# Access Compliance Report

## Public Rights-of-Way (Curb Ramps)

Intersection ID: 48320	Main Street: NORTHLAKE_MALL_DR	Cross Street: NORTHLAKE_COMMONS_BV	Location: SW
ADA ID: 7BA2859B4801	Ramp Type: Perp	Initial Pass/Fail: Fail	Overall Compliance: No
Severity Score: 18.75			
Codes/Mitigation Info/Possible Solution		Field Measurements/Component Compliance

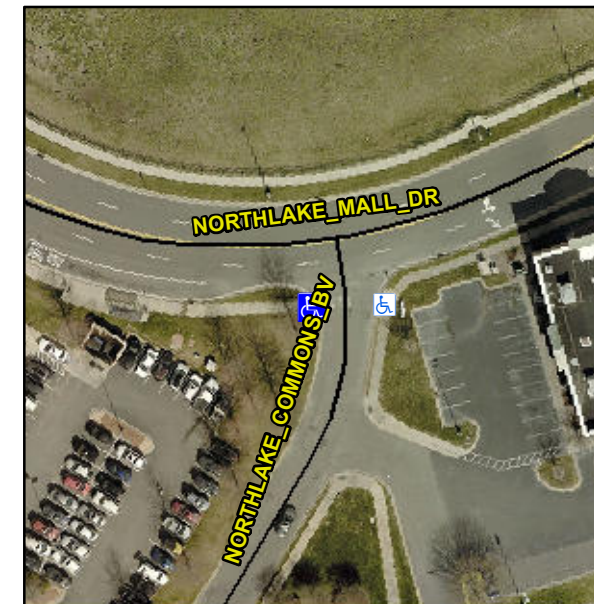
**Not Found, R304.5.1, R304.5.3**

Compliance	Description	Data	Compliance	Description	Data
N/A	Ramp Length (in)	77.0	Yes	Ramp Slope (%)	6.0
No	Ramp Width (in)	35.0	No	Ramp XSlope (%)	3.2
N/A	Flare Type LT	N/A	N/A	Flare Type RT	N/A
N/A	Flare Slope LT (%)	N/A	N/A	Flare Slope RT (%)	N/A
N/A	Flare Traversable LT?	N/A	N/A	Flare Traversable RT?	N/A
N/A	Landing Length (in)	N/A	N/A	DWS Provided?	N/A
N/A	Landing Width (in)	N/A	N/A	DWS Contrast?	N/A
N/A	Landing Slope (%)	N/A	N/A	DWS Length (in)	N/A
N/A	Landing X Slope (%)	N/A	N/A	DWS Full Width?	N/A
N/A	Landing Curb? (Y/N)	N/A	N/A	DWS Offset (in)	N/A
N/A	Shared Landing?	N/A			
N/A	Gutter Ponding?	N/A	N/A	Gutter Slope (%)	N/A
N/A	Gutter Lip Ht (in)	N/A	N/A	Gutter X Slope (%)	N/A
N/A	Painted X Walk1?	Yes	N/A	Painted X Walk2?	N/A
	X Walk 1 Direction	To E		X Walk 2 Direction	N/A
N/A	X Walk 1 Width (in)	60.0	N/A	X Walk 2 Width (in)	N/A
	X Walk 1 Slope (%)	0.7		X Walk 2 Slope (%)	N/A
	X Walk 1 X Slope (%)	2.8		X Walk 2 X Slope (%)	N/A

**Remove & Replace Entire Ramp.**
